BOARD OF APPEALS, CITY & COUNTY OF SAN FRANCISCO

NOTICE OF APPEAL

The substance or effect of the decision or order appealed from is the ISSUANCE on December 18, 2023 to Jennie Chien, of a Site Permit (erect a one-story, Type 5 greenhouse/ceramic studio in rear yard; erect two-story Type 5 building single-family home with basement consisting of greenhouse ceramic studio) at 681 12th Avenue.

PRELIMINARY STATEMENT FOR APPEAL NO. 24-001

Exhibit 6 Patio at 681 12th – to be converted to covered walkway. No part of the proposed ceramic art studio is contained within the patio space.

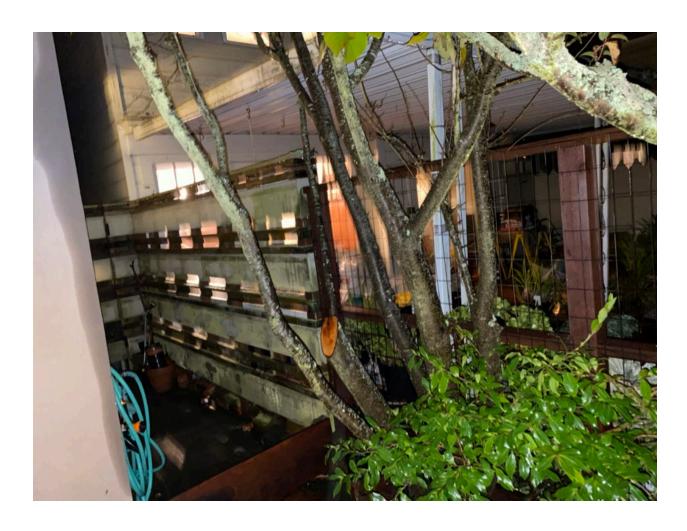
This ceramic art studio is not freestanding but adjoined to the house via a covered walkway. It's intended use is a work studio for an artist. The permit holder is essentially putting her home work office into the open space backyard. It is reasonable to expect home work offices to be private. A glass workspace, 100% visible to the adjoining properties should not be permitted in the backyard. Especially a design that is all about the interior space. As it is now, the permit holder is imposing her private living area into the adjacent backyard open space.

This is an Accessory Structure as defined by the Planning Code. It was designed to be used as an art studio. It is not a living space. It is a freestanding structure. The canopies are attached to the residence and designed as protection from wet weather. The permit holder is not passing this off as a greenhouse, it is correctly labeled a Ceramic Studio on the permit drawings and

Exhibit 9 Light emission from within a building – 679 12th Avenue

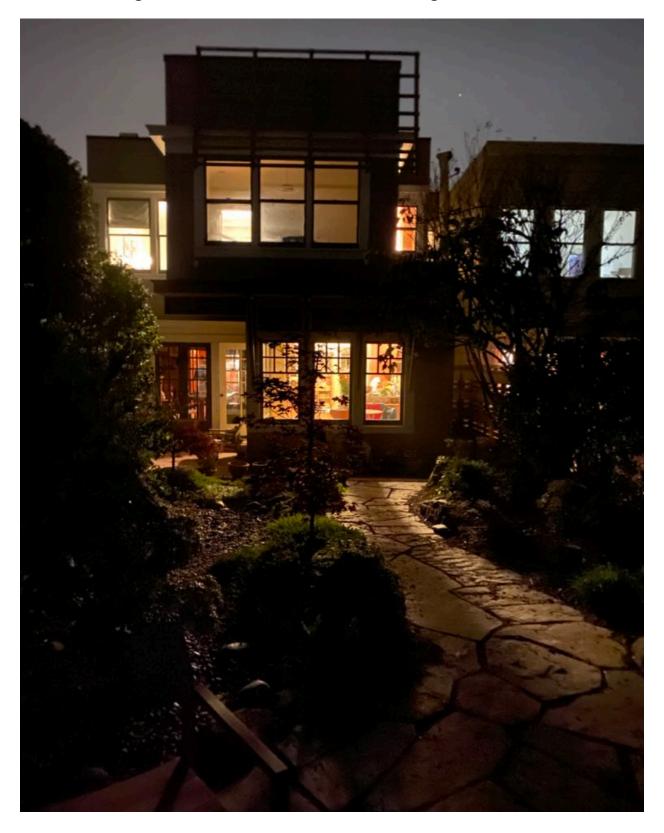
Objection #2 It will create an unacceptable amount of light pollution

This is a glass box, 13' feet high, higher than the nearby extensions, with a transparent ceiling - in the mid block open space. It necessarily emits light.

Response to Objection #2: It will create an unacceptable amount of light pollution.

There never has been any intention to brightly light the studio. This would be wasteful as well as inefficient. At night task lights will be shielded and directed downwards and not up at the sky or directed towards neighbors. Lighting, whether track lighting or pendant lighting will also be shielded focused down lighting. The window manufacturer informed the design team that the addition of third-party films on the glass would void the warranty, therefore the owner made the decision to use tinted glass with a low-e reflective coating to help control light, increase the amount of privacy, and reflect the landscape of the rear yards during the day. The tinting will cut down on light escaping during the evening hours and will reduce visibility of the interior during the day. Window coverings will also be employed as needed to control light and provide additional privacy.

1. The glass manufacturer informed us that using film on the glass would void the warranty

of the glass system. The decision was made to change to a tinted gray glass with low-e

coating. This will help the privacy / visibility concerns during the day and with light

EXHIBIT 1 PROPOSED PLOT PLAN

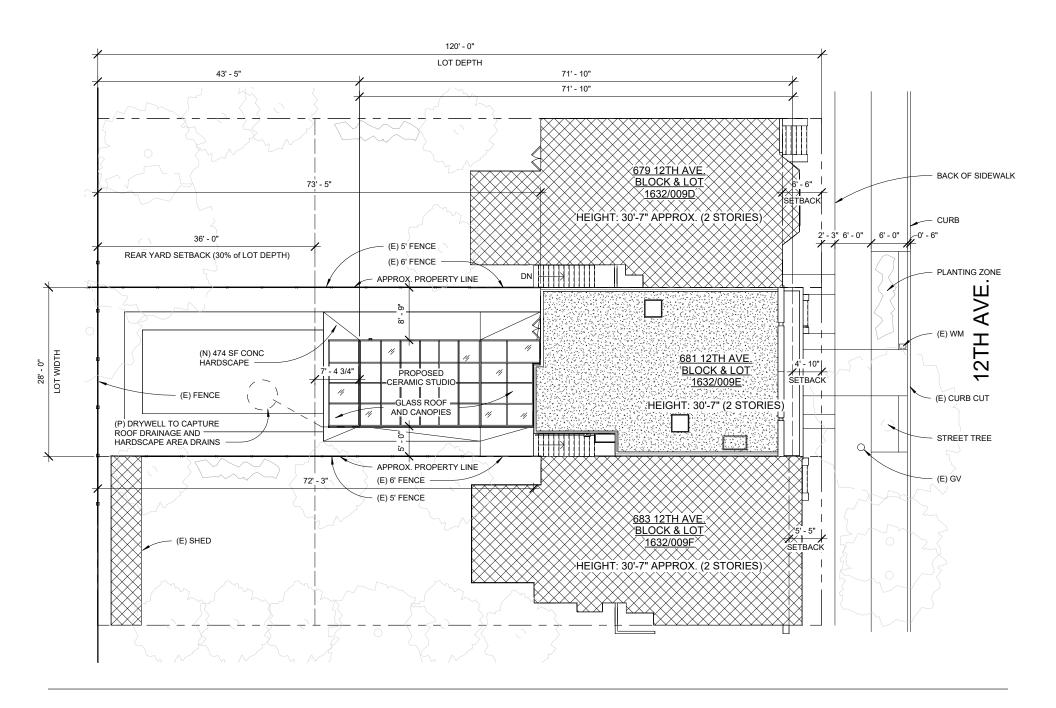
Objection #1 Violates Open Space

The permitted project erodes the long established mid-block open space, open space that is a

defining feature of this block. It's a hidden gem in the inner Richmond. There is a consistent

block pattern of building out no more than 10' from the rear of the house and this building goes

The total square footage of the rear yard is 2,038 square feet, of which, the Ceramic Studio

takes up 285 square feet, or 14%. The Planning code open space requirement for RH-1 zone is

a minimum of 300 square feet. The proposed project preserves 1,753 square feet of open

space.
